## IDAP REPORT

<b>Property:</b>	18 Bennett Avenue STRATHFIELD SOUTH DA 2020/52
<b>Proposal:</b>	Demolition of existing buildings and construction of a new two-storey dwelling, in-ground swimming pool, cabana, associated landscaping works and boundary fencing.
<b>Applicant:</b>	Roth Architecture Workshop Pty Ltd
<b>Owner:</b>	Marco Coscarella / Sarah Coscarella
<b>Date of lodgement:</b>	18 March 2020
<b>Notification period:</b>	20 March 2020 to 05 April 2020
<b>Submissions received:</b>	None
<b>Assessment officer:</b>	P Santos
<b>Estimated cost of works:</b>	\$1, 362,500.00
<b>Zoning:</b>	R2 – Low Density Residential - SLEP 2012
<b>Flood-affected:</b>	No
<b>RECOMMENDATION OF OFFICER:</b>	REFUSAL

**Figure 6. Extract of the north elevation prepared by Roth Architects, dated 13/03/2020**

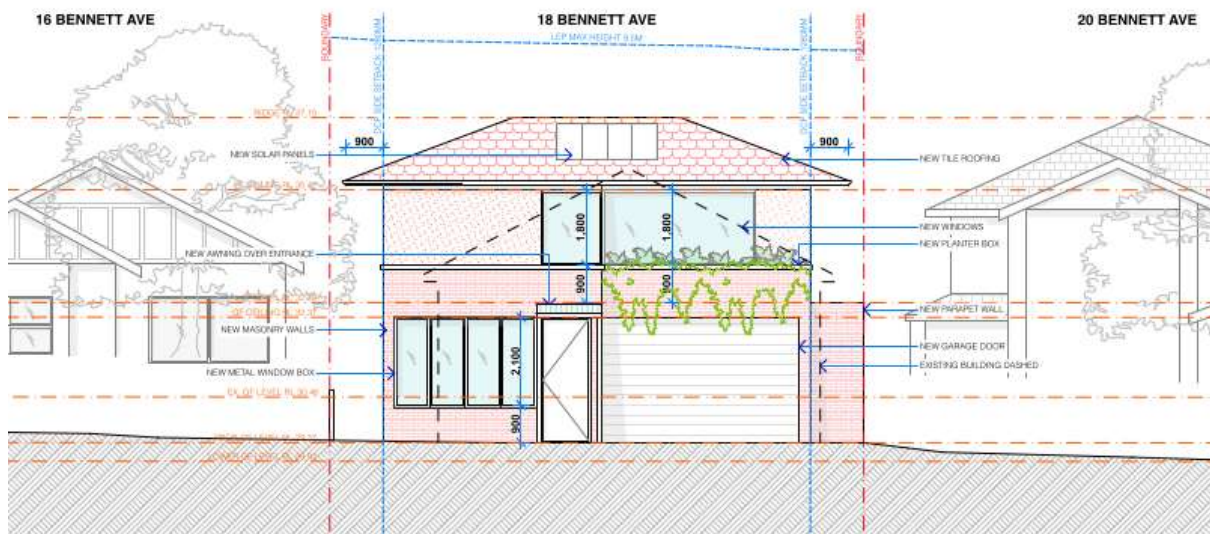
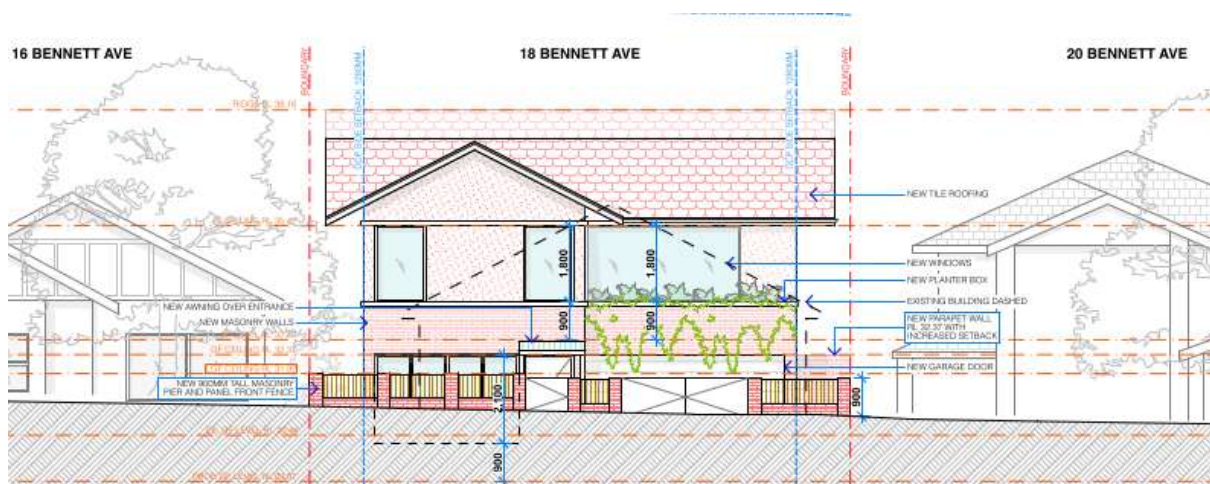
In a preliminary assessment of the application a concern was raised that the initial design of the proposal is not consistent with the current streetscape. While the subject site and neighbouring properties are not within a Heritage Conservation Area, Figures 3 and 4 show that there is a distinguishable character of one to two-storey dwelling houses that have gable roof features facing the street.

As seen in Figure 6 below, the original design incorporated a hipped roof form.

The application was requested to include a similar feature, which resulted in the final design shown in Figure 7 below.

While the final design presents a gable feature to the street, the roof-form also included gable features that face the neighbouring dwellings. These result to a squared roof when viewed from the street, which deters the characteristic rhythm of gabled houses along Bennett Avenue—as illustrated in Figure 8 below, taken from Council’s SDCP 2005.

**Figure 10. Extract of the Tree Location Map (source: The Tree MD)**

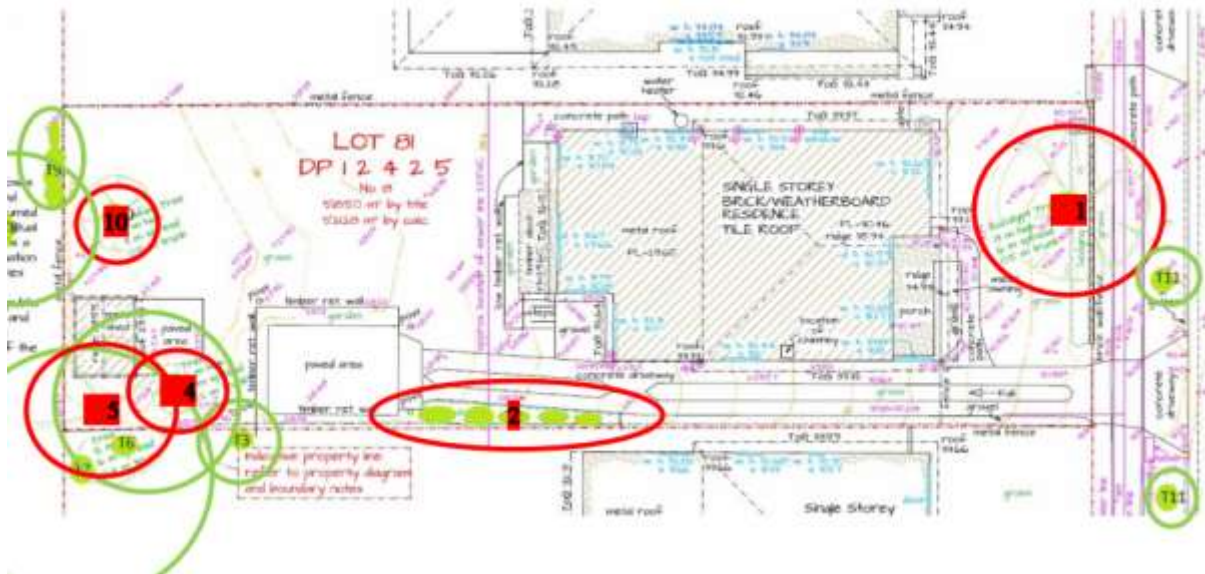
The site visit undertaken by the Assessment Officer has revealed that a street tree will be on the way of the proposed new driveway. The submitted arborist report discussed the street tree. However, the location of the tree in the report is incorrect.

The report indicates that the subject tree in front of the dwelling house that is on Council verge is located closer to the existing driveway. As shown in Figure 9, the tree is actually located closer to the western boundary of the subject site, which is estimated to be, if not on the way of the new driveway, closer to it than what the Arborist Report indicates.

The SDCDP 2005 states that – “Council will not give Consent for a new vehicular crossing including layback to be installed closer than 2m (radial measurement, measured from the tree’s base) from a street tree”. As such, the proposal is not supportable in this regard.
